NRC DOCKET#: NRC-2012-0246

TITLE: Waste Confidence—Continued Storage of Spent Nuclear Fuel

**Pilgrim Watch Comment Regarding the NRC Proposed Waste Confidence Rule –
Continued Storage Spent Nuclear Fuel [RIN 3150-AJ20-NRC 2012-0246],**

Mary Lampert
Pilgrim Watch, Director
148 Washington Street
Duxbury, MA 02332
Tel. 781-934-0389
Email: mary.lampert@comcast.net
December 19, 2013

Figure 1 The Bathtub Curve

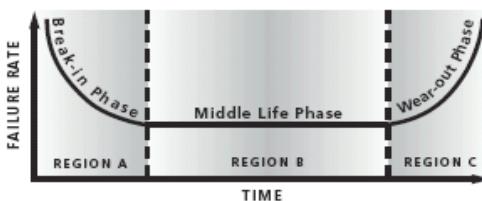
- 14. No analysis of age degradation of the pool and refueling cavity for the 60 years following license expiration.** Pilgrim for example was built in the late 60's when Lyndon Johnson was President and the NRC Confidence Decision assumes that the pool would have structural integrity through 2092. There is neither industry experience to rely on nor any other basis for that determination. Engineers explain the aging phenomenon by using what is known as the "Bathtub Curve." The curve is a graph of failure rate according to age. The failure rate is relatively high in the beginning when "kinks" are being worked out; it flattens out during the middle life phase; and it rises again sharply in the end-of-life or at the "wear-out phase." On average, 20 to 30 years usually marks the beginning of the wear-out phase. And the rate of corrosion is not linear over time.
